# CITY OF ALBUQUERQUE

**RE: PHS Aloft Plaza  
9201 San Mateo NE  
Conceptual Grading and Drainage Plan  
Engineer's Stamp Date: 1/17/20  
Hydrology File: B17D001B**

Based on the submittal received on 1/21/20, the Conceptual Grading and Drainage Plan cannot be approved until the following corrections are made:

PROPOSED DMP

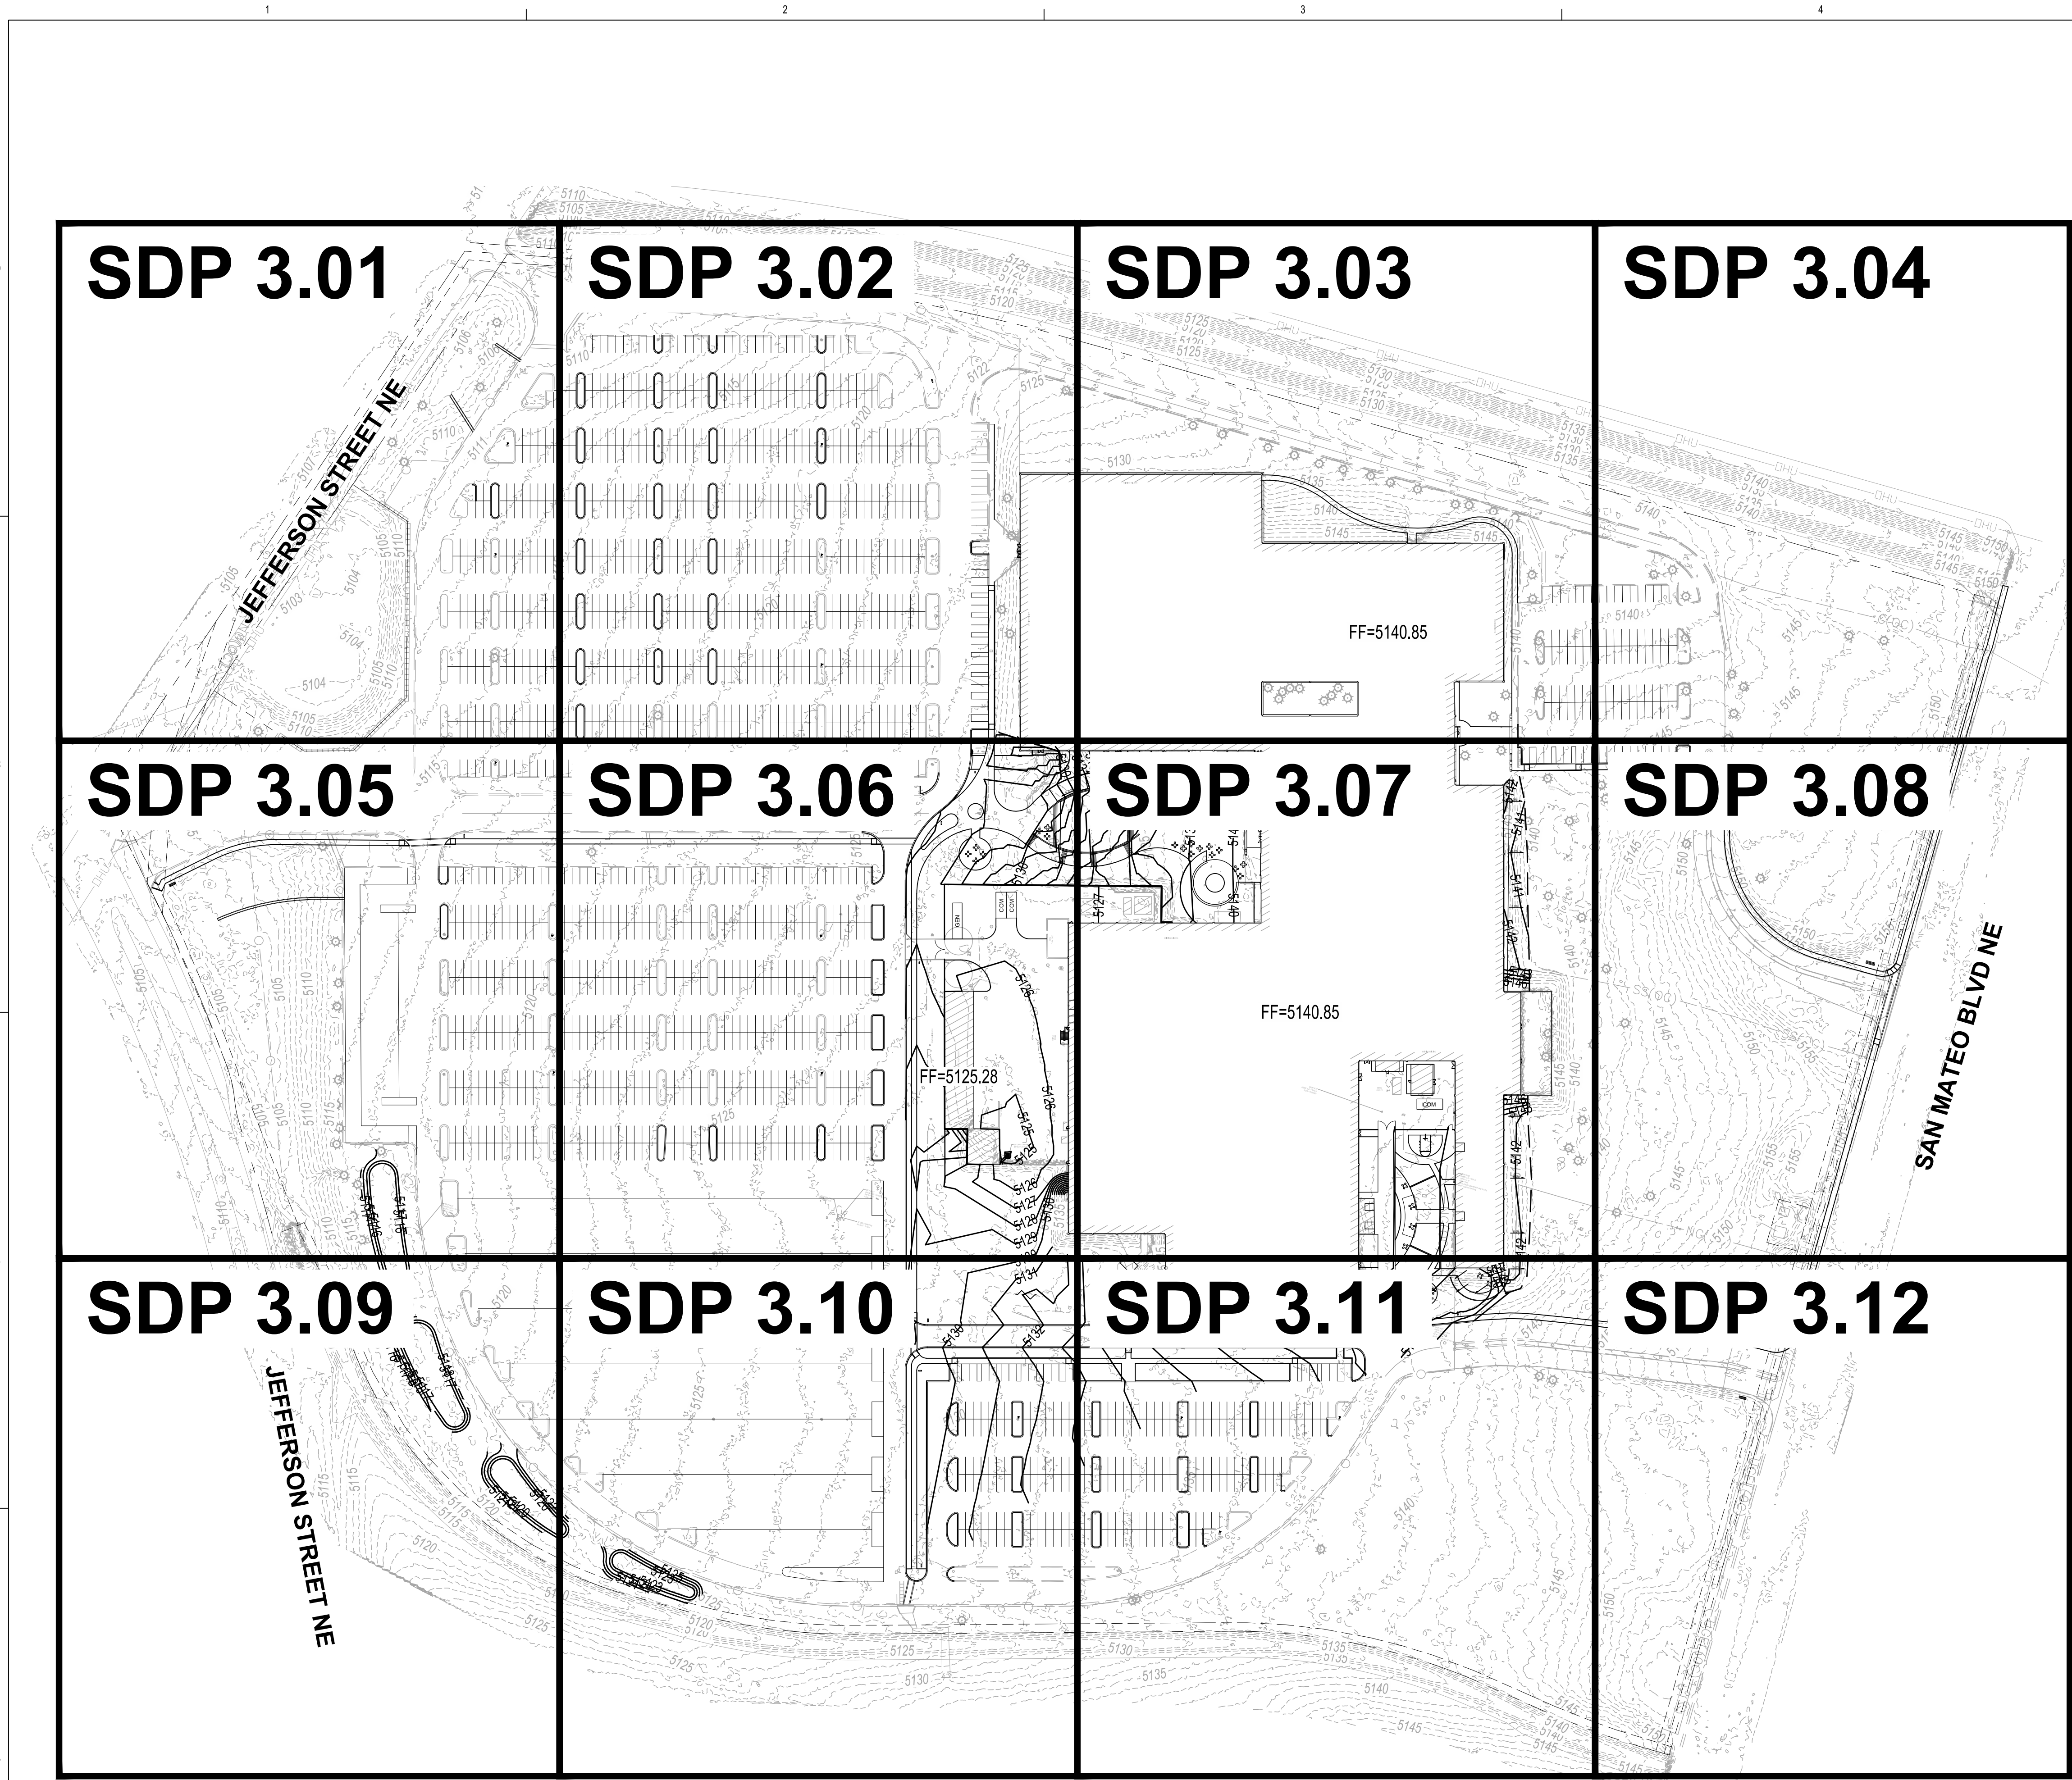
1. Please provide the stormwater quality volume (SWQV) calculations for each basin draining to each pond. The stormwater quality ponds need to be sized for the areas draining to them. For instance, Basin 1 required SWQV is 15144cf, but the only apparent ponding area (Basin 5) is 5292cf.
